CITY OF DOVER

PLANNING TECHNICAL REVIEW COMMITTEE –AGENDA

RE: "Settlement on 6th"
Settlement on 6th LLC
Sixth Street
Transfer of Development Rights Subdivision
Map B, Lot 5

On behalf of Settlement on 6th LLC, Berry Surveying and Engineering (BS&E) submits to TRC a proposed TDR subdivision off Sixth Street. The plans and design have been revised based on comments made by the first TRC on August 12, 2021. Our responses are in **bold**.

GRADING PLAN & PROFILE WILDCAT DRIVE 5+50-10+95
LAND OF
SETTLEMENT ON 6TH, LLC
SIXTH STREET
DOVER, N.H.
TAX MAP B, LOT 5

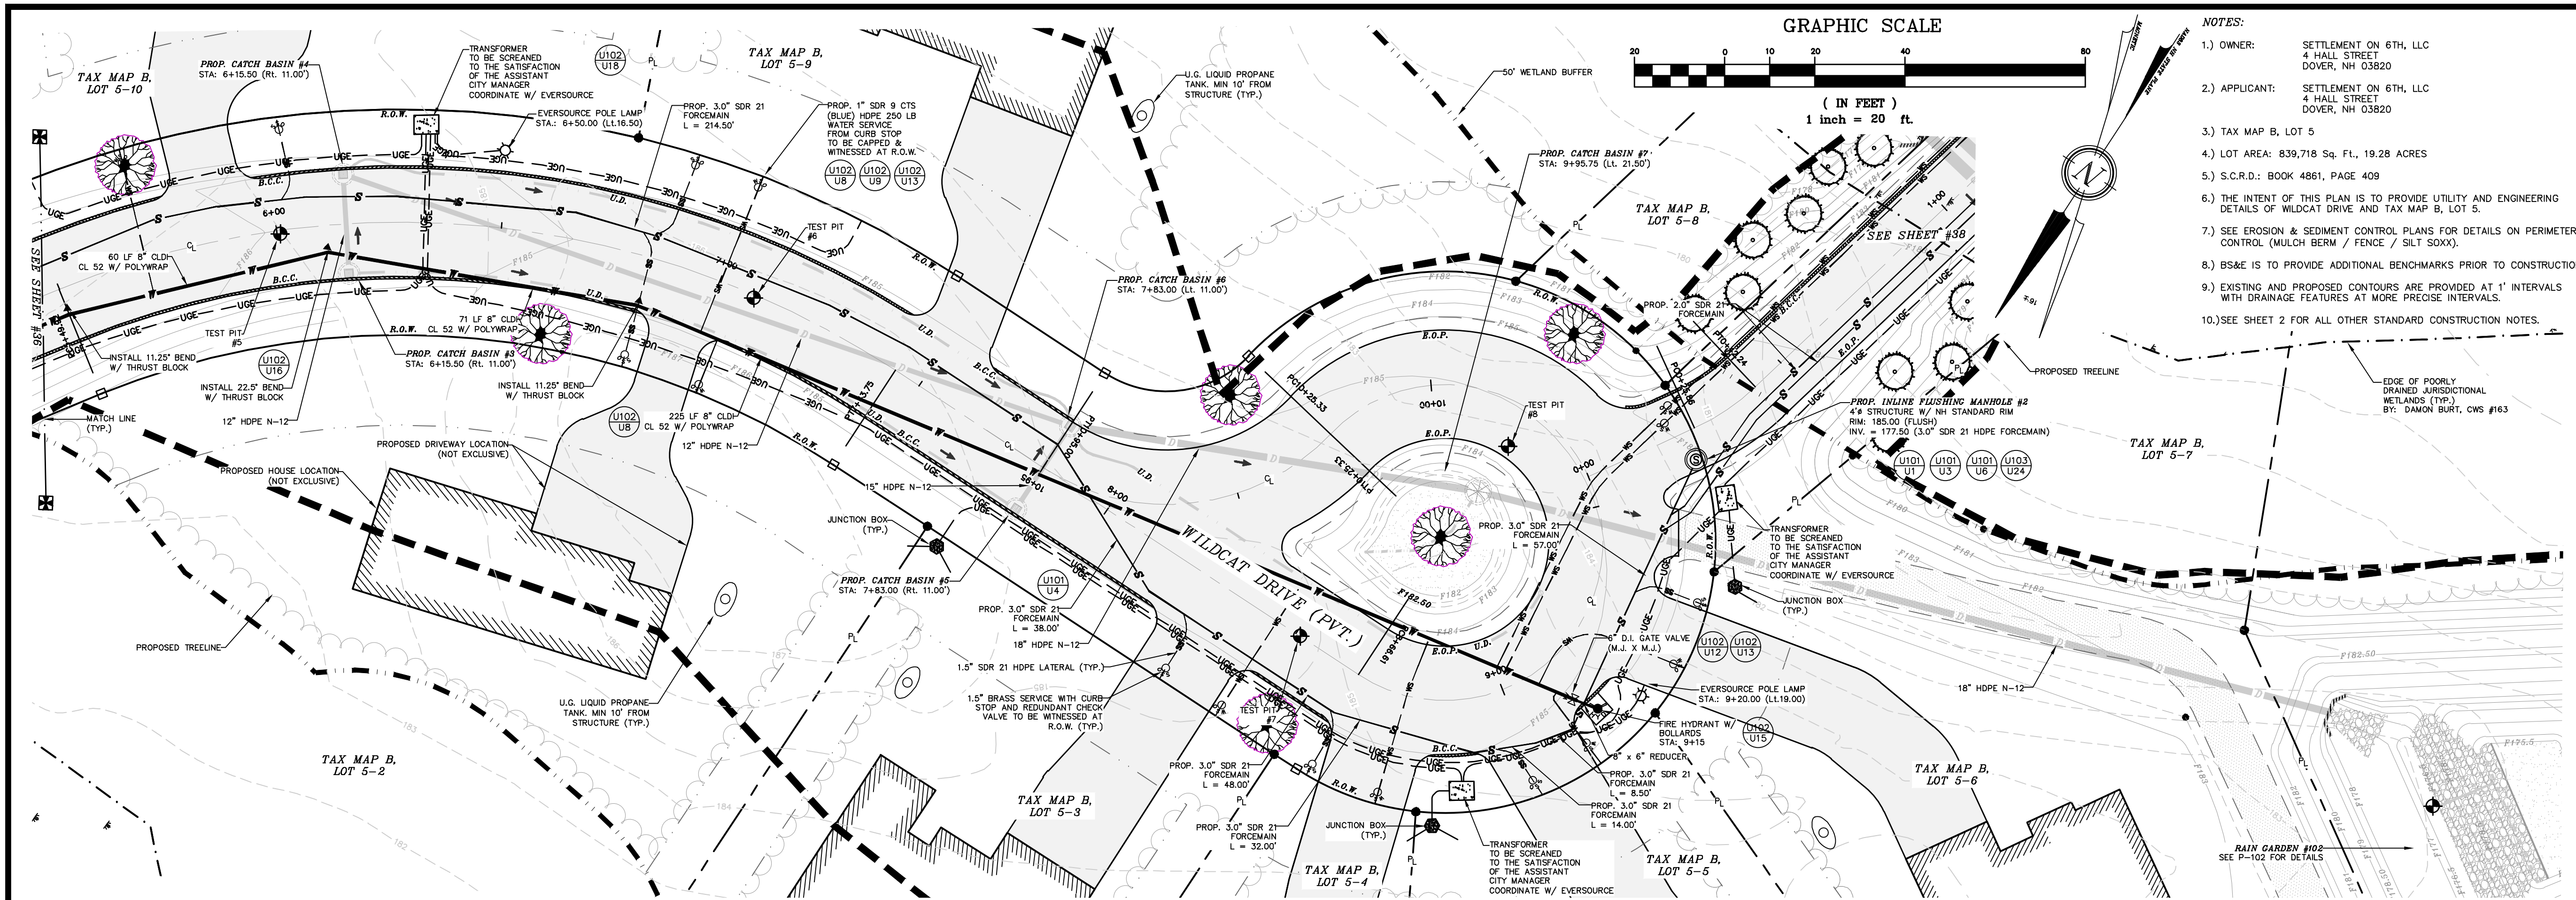
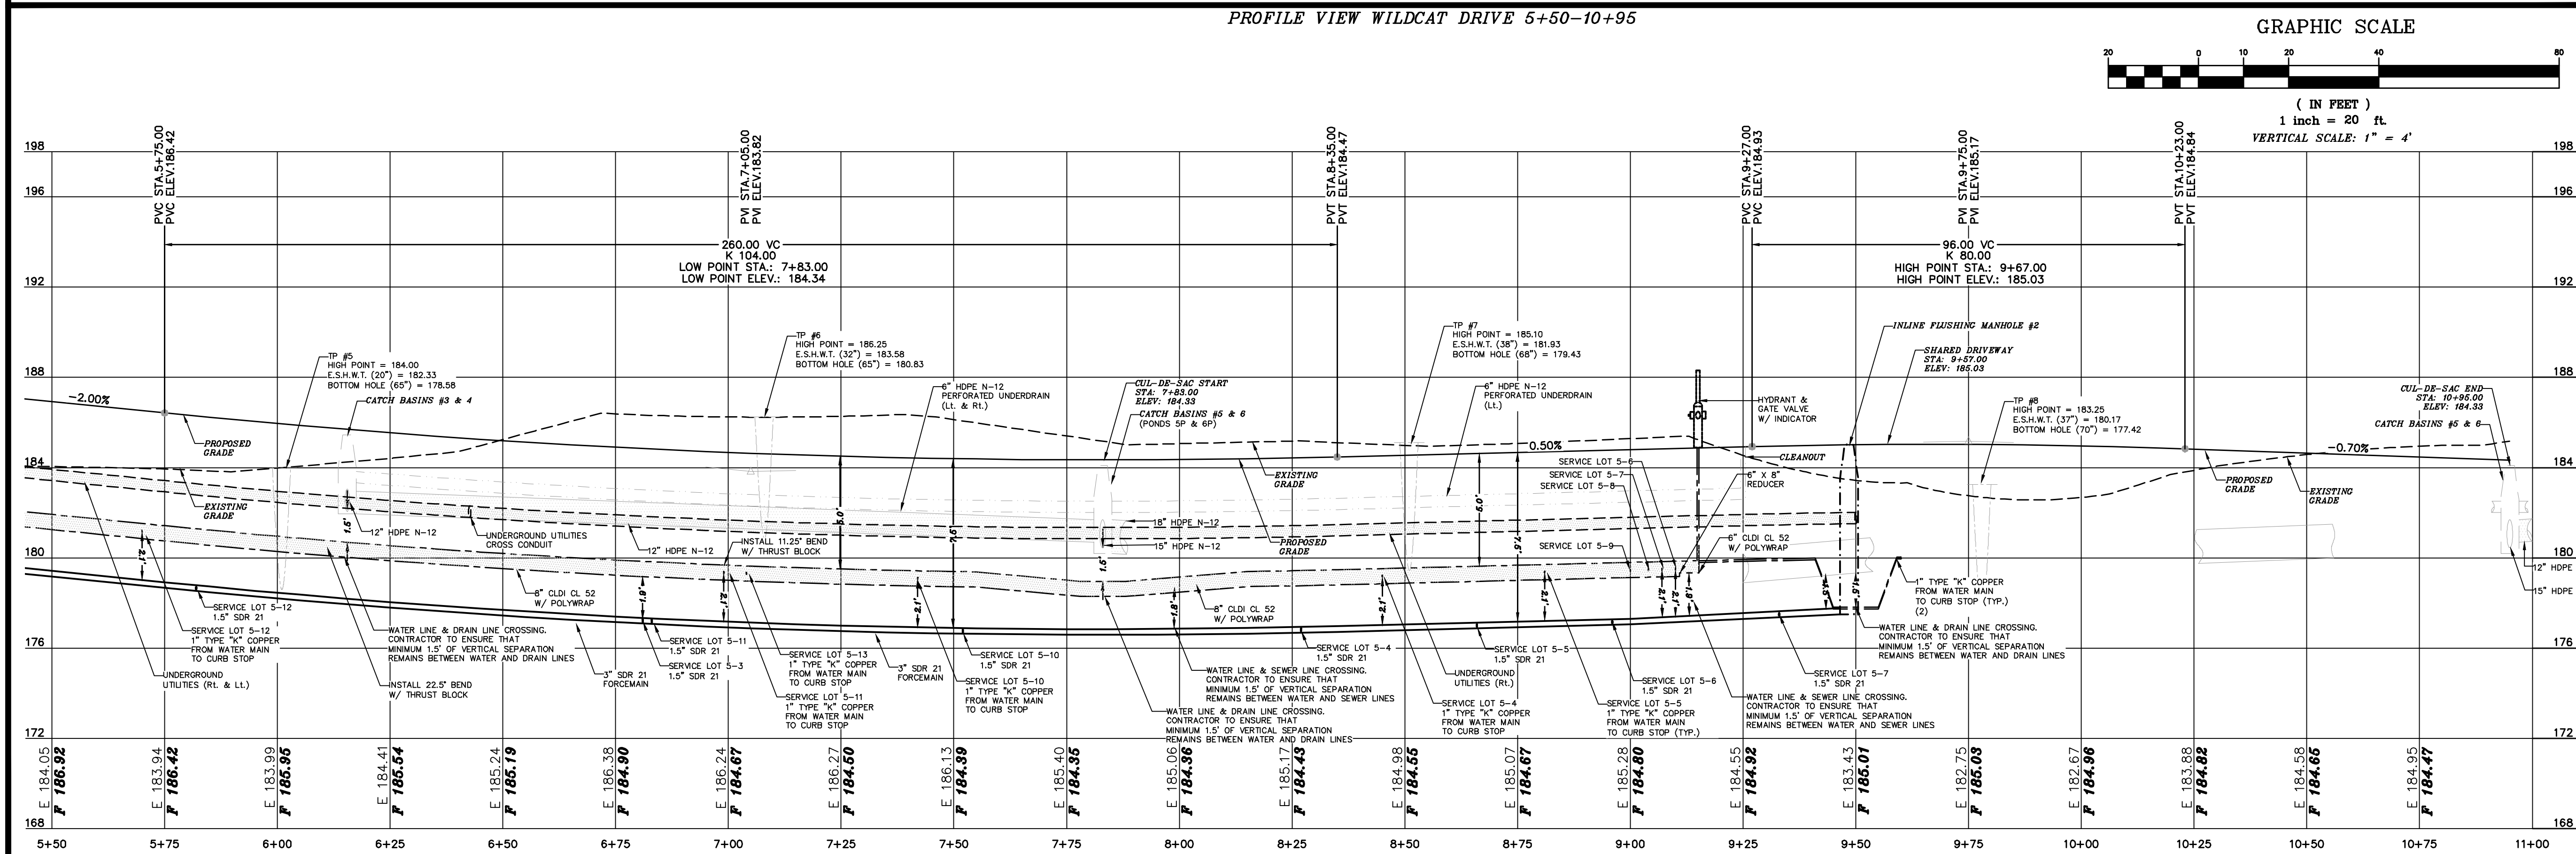
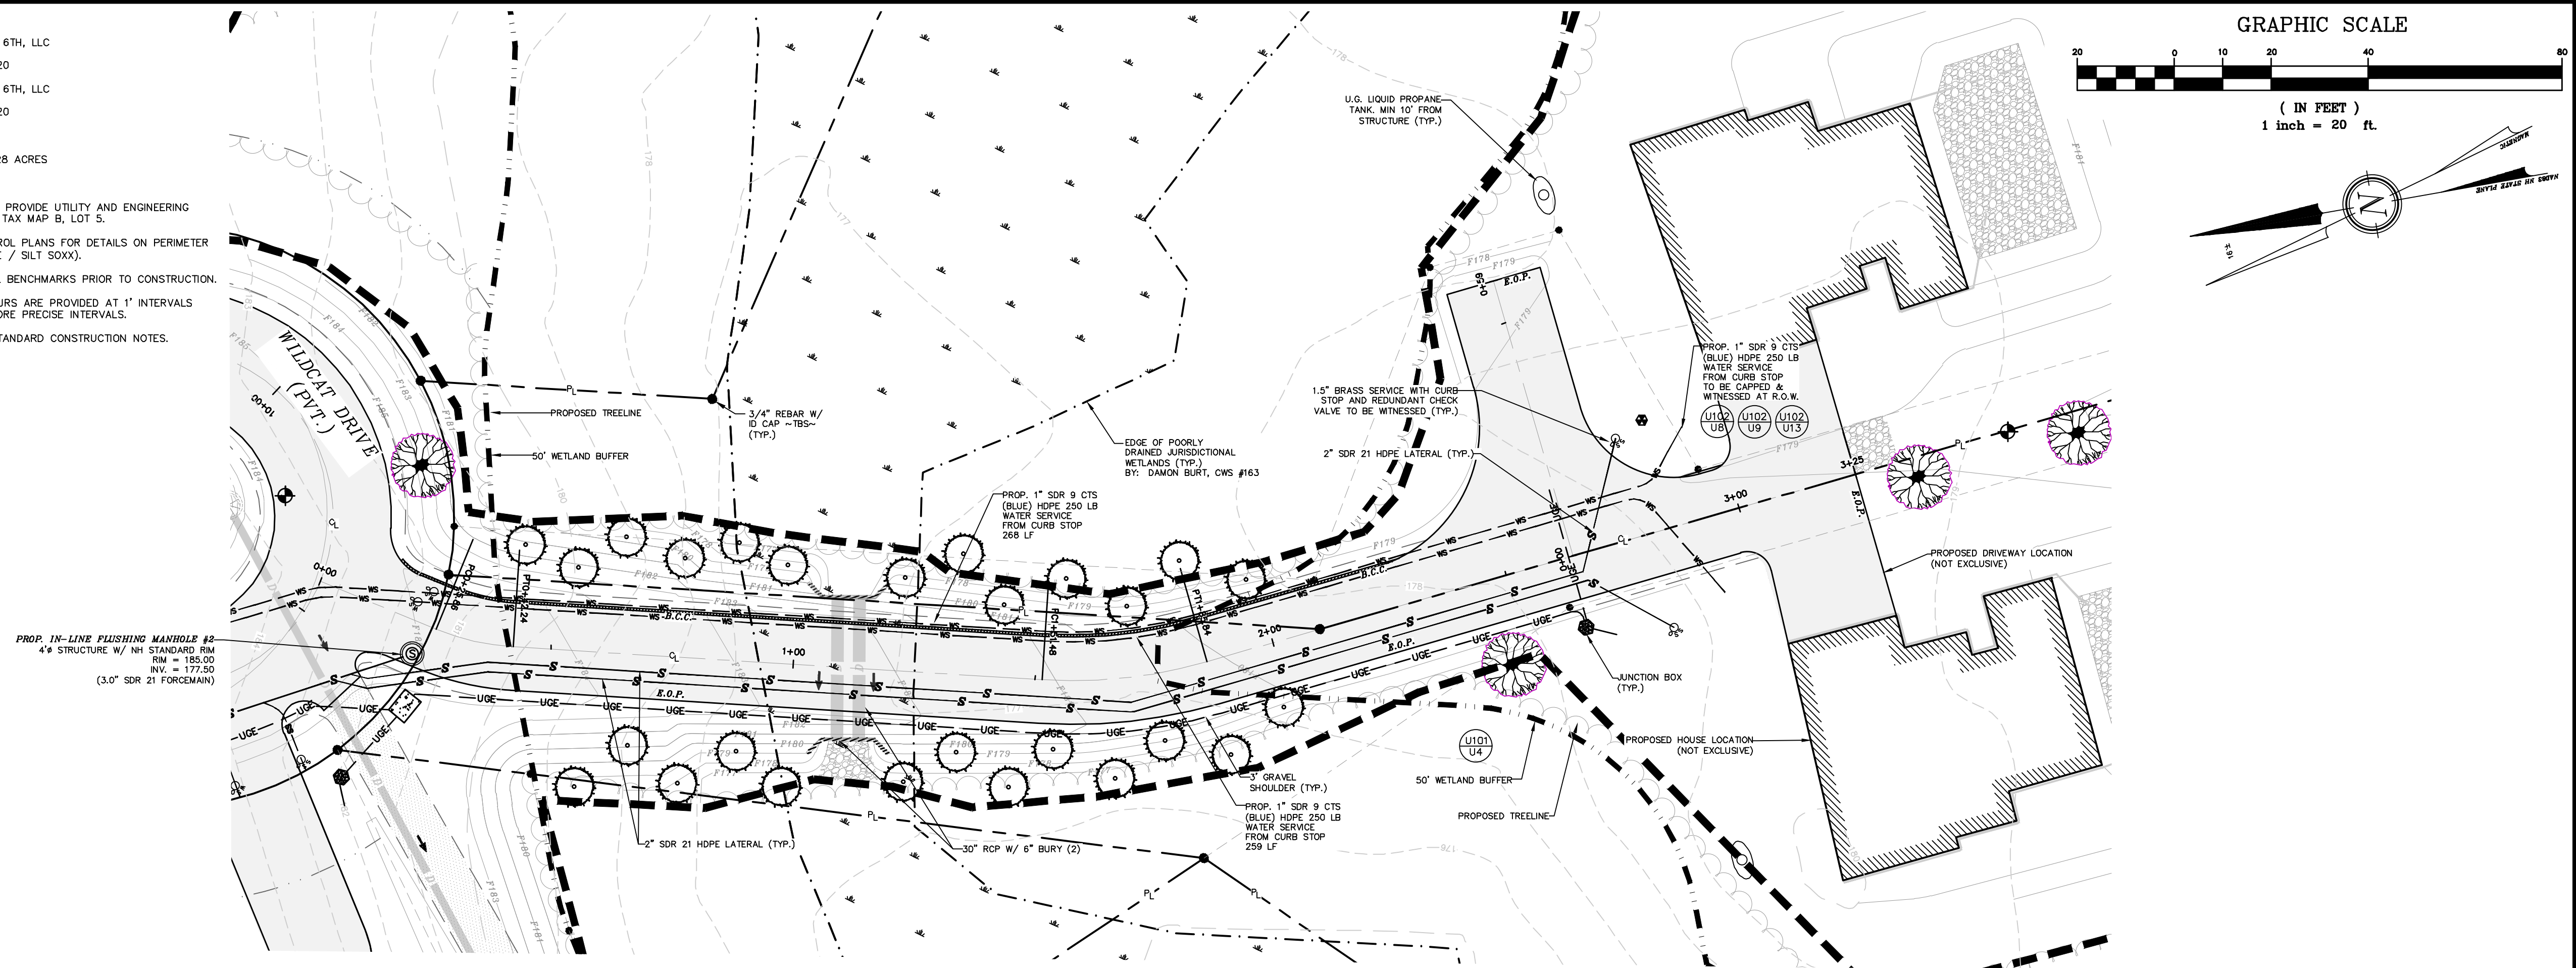
- Investigate gravity sewer to the RR easement or Cottonwood
The contractor will investigate the sewer prior to construction.
- Move no outlet sign closer to the entrance.
Outlet sign has been moved closer to the entrance, to station 0+60
- Check the invert grades on cb1 and 2. They are the same
The inverts of cb1 and cb2 are correct.
- Suggest adding another cb at 7+10 to realign pipe to give more room for other utilities
The utilities have been revised to allow for at least 5' of separation to the drain line at station 7+10.
- Move the water into the row around sta 700
Water line has been moved into the roadway at station 7+00.
